STATEMENT OF PROPOSALS

Coastal Quarter SHD 2 Planning Application

IE000468
Coastal Quarter SHD 2, Bray
F01
14 September 2022

Figure 3-1: Site Considerations and Potential Luas Line
 Source: Harbour Point Masterplan Glenn Howell Architects

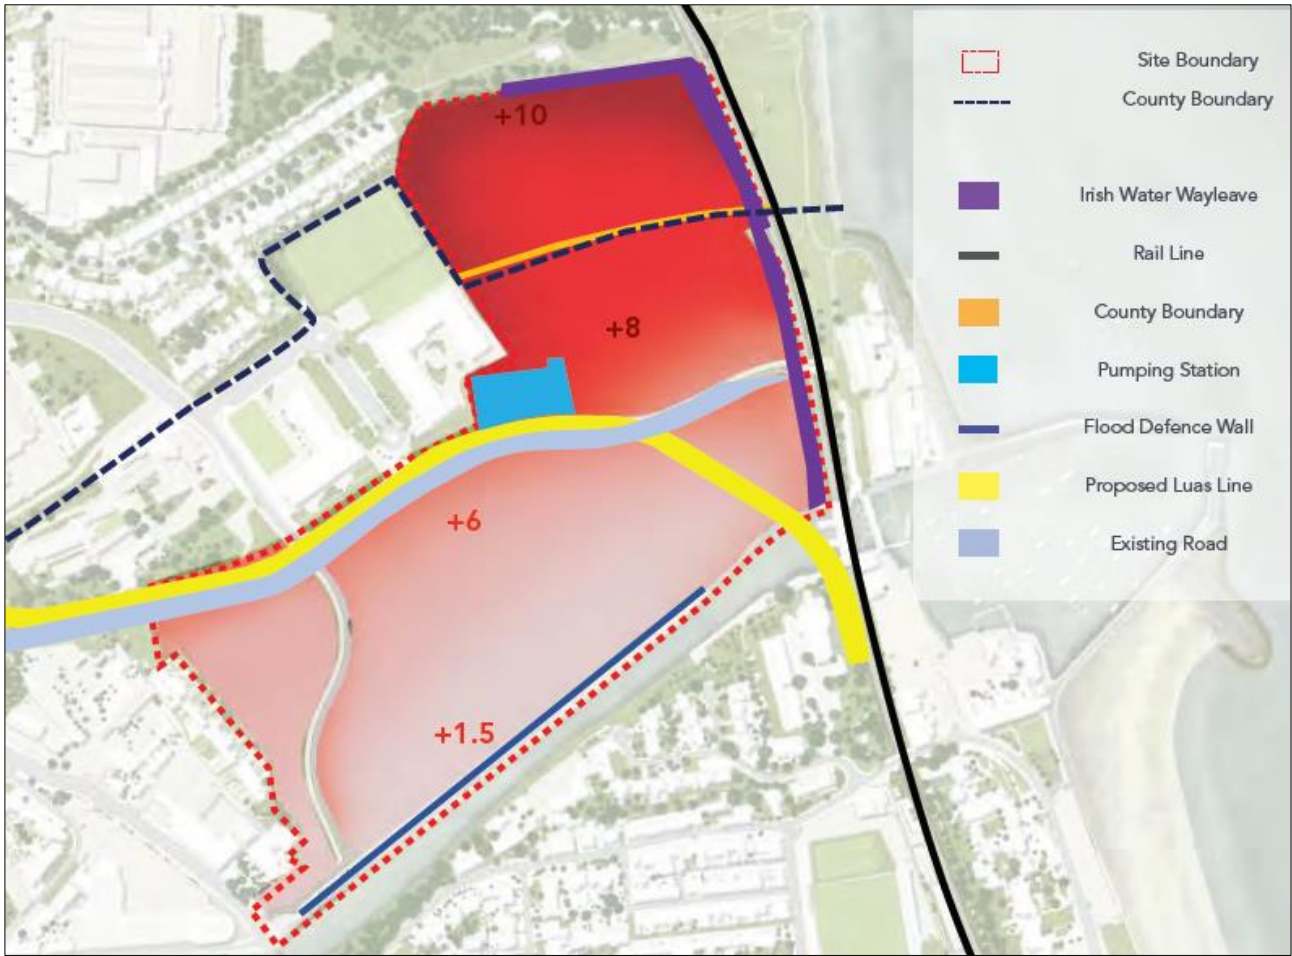
“Further consideration / amendment or justification of the design and layout of Block 1C to provide a strong urban edge for the development, in particular the ground floor uses on the southern elevation which front onto the ‘Market Square’ and future potential Luas Line.”

In developing a framework for the former Bray Golf Lands (Harbour Point), both of these projects have been considered and facilitated within the proposed masterplan layout thereby enabling their delivery. In addition, the area is constrained by wayleaves and the applicant has gone to considerable lengths to agree a diversion with IW to enable the subject site be developed in a coherent manner, including the location of Block C. The *Harbour Point Masterplan* prepared by Glenn Howell Architects is included as part of the application. The future public transport route is illustrated in yellow on **Figure 3-1** below.

This future public transport link provides a natural divide to create two distinctive urban quarters, the southern area facing onto the River Dargle, the River Quarter, and the northern area facing the coast and bounded by the schools complex to the west and possessing the ability to access panoramic views over the Dart railway line to the sea and coastal areas, the Coastal Quarter.

Figure 3-5: Site Layout showing distance Building 1D from Existing Development

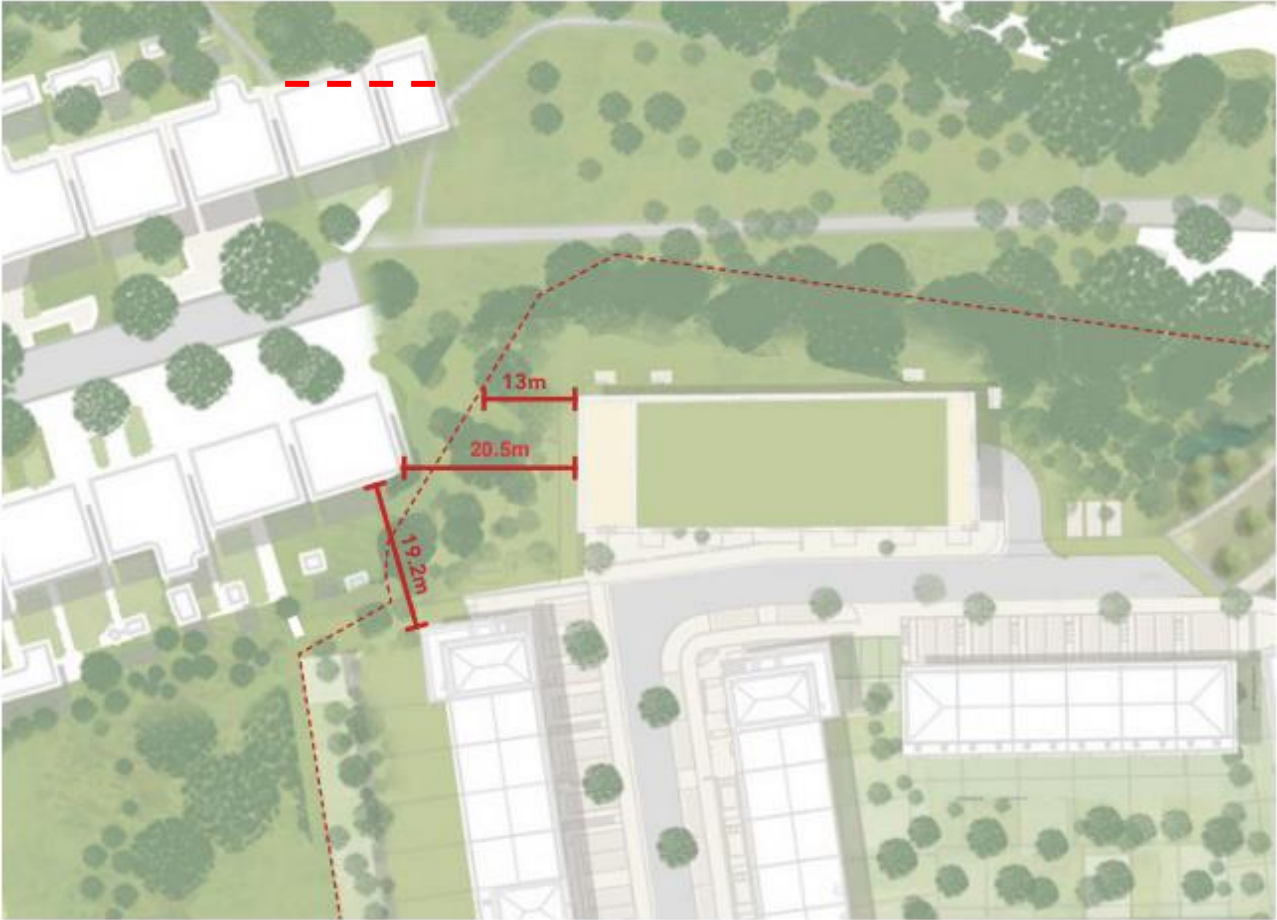
“Further consideration / amendment or justification of the scale and bulk of Block 1D having regard to the residential amenities of the adjoining properties and the visual amenities of Woodbrook Glen and the open space zoning objective of lands located to the north of the site.

A small proportion of the site perimeter at one location has existing housing close to the boundary. This occurs on the north west corner of the Coastal Quarter where 112 Corke Abbey shares the site boundary, and apartment building Block D is the closest building to that boundary. Following receipt of the Board’s notice under ABP 308291-21 the design was refined to include:

- Moving Block D east by 2m and south by 2m increasing the distance from the existing house to 20.5m (see **Figures 3-5 and 3-6**);
- Reducing the overall scale of Block D from 5-storeys to 4-storeys;
- Setting back the fourth floor to the west and east so as to minimise overlooking and to stepdown the building towards the neighbouring 2-storey house to the west;
- Pulling back the terrace at fourth floor level from the parapet wall to further reduce overlooking; and
- Ensuring that balconies have not been provided on the western elevation in order to minimise overlooking.
- A particular house type in which a number of first and second floor gable windows were removed was designed and placed on the end of terrace duplex apartments closest to Corke Abbey

The apartments in Block D closest to the neighbouring housing will have their primary orientation and balconies either on the north or the south elevations. Those windows facing west towards the neighbours will be smaller windows to provide the apartments with a secondary orientation. One apartment on the top floor has a west facing roof terrace but the balustrade for this terrace is set back from the buildings parapet so that there is no overlooking of the neighbours back gardens from this level. In addition to the careful placement of windows and balconies on Block D the existing trees along the boundary are retained.

Figure 3-7: Uses Proposed within the Orchard

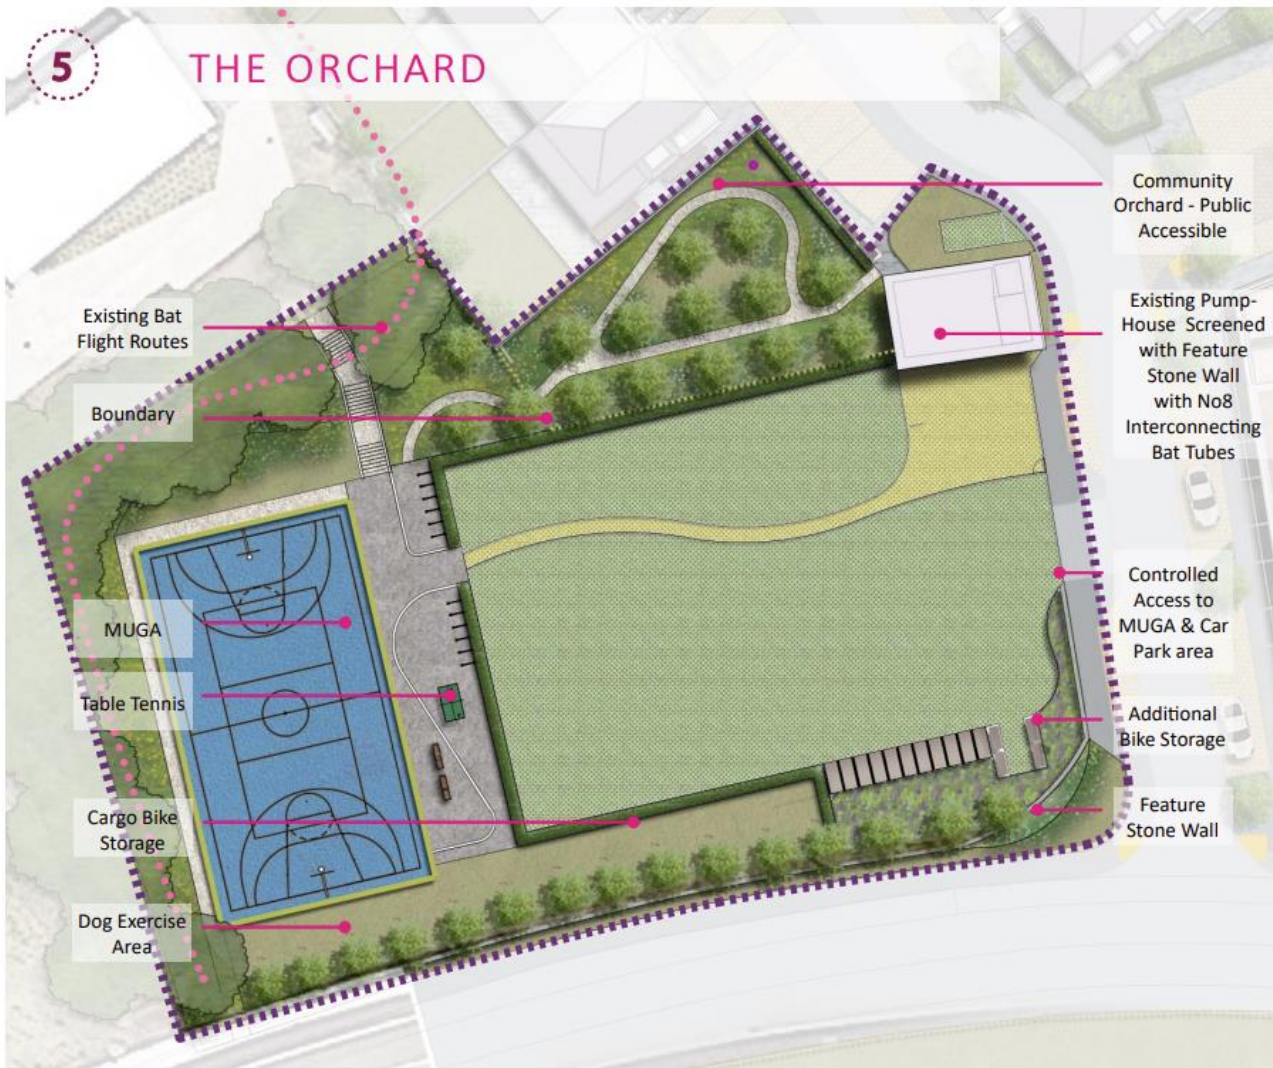
“Further consideration / amendment or justification of the proposed surface level car parking at ‘The Orchard’ along the southern site boundary, having regard to the proximity to existing and proposed public transport infrastructure and the potential negative impact of surface level car parking on the public realm.”

In response to conditions on the ABP 311181-21 approval, the previously proposed area of car parking has been removed and replaced with a secure location for bike rental, secure bike parking (both standard and cargo bikes), EV charging for electric bikes and provision of two GoCar spaces to facilitate car sharing. The boundary treatment has also been amended to a more visually transparent option of low brick wall and railing with a feature name sign to mark it as a primary entrance to the Coastal Quarter development.

Access will be by separate controlled vehicle and pedestrian gates. The vehicle gates also allow controlled access for maintenance vehicles to access the pumping station. The area of soft landscape to the north of the car park will have full public access and will be planted with ornamental fruit trees to define the orchard character of the open space. A native screen planting buffer will also be created along the site boundary with the school to maintain existing bat flight routes in the locality. The proposed layout is illustrated in **Figure 3-7** below.

Figure 3-9: Temporary Secondary Emergency Access

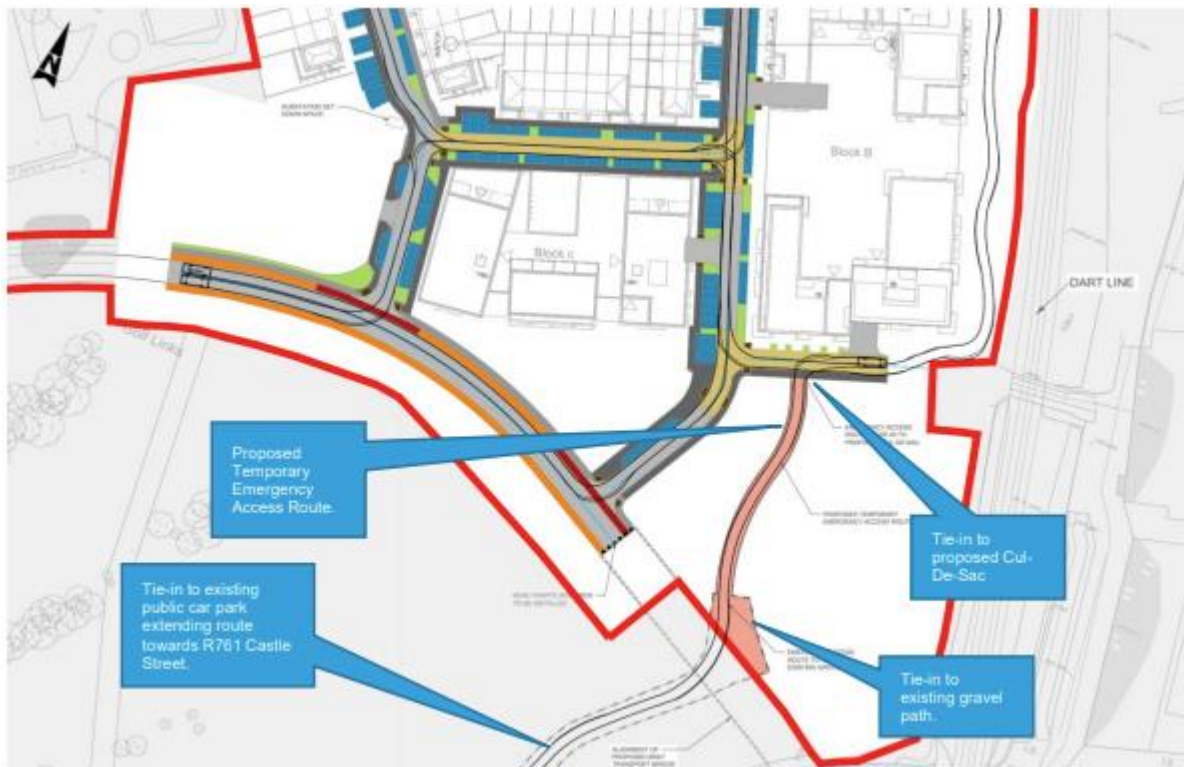
“Further consideration of the documents as they related to access and emergency access to the site. Clarity is to be provided concerning who is to deliver the proposed road network; the status of any planning and other consents required to deliver the infrastructure; the timelines involved in the delivery of the required infrastructure in the context of the proposed strategic housing development. Further consideration of the concerns raised in the report of Dun Laoghaire Rathdown County Council’s Transportation Planning Section dated 13th October 2020 and concerns raised in the report of Wicklow County Council’s Roads Section dated 15th October 2020.”

In addition, a further temporary secondary emergency access point has been provided, as shown in **Figure 3-8**. This emergency access point is provided towards the south of the site and connects via a vehicle crossover with the cul-de-sac adjacent Block B and will route through the open space provision south of this, before tying in with the existing gravel path which ultimately leads to the public car park and onto the R761 Dublin Road/Castle Street. The emergency access road which routes through the open space provision will consist of reinforced grass construction and will in part overlap with the paths proposed within the open space. The landscape scheme has been designed to accommodate the emergency access and road levels can be accommodated by the existing ground levels so as not to raise levels in this flood zone area.

This proposed temporary secondary emergency access road will intersect with the alignment of the future public transport road. The need for the temporary secondary emergency access route will be replaced once the public transport bridge is built.
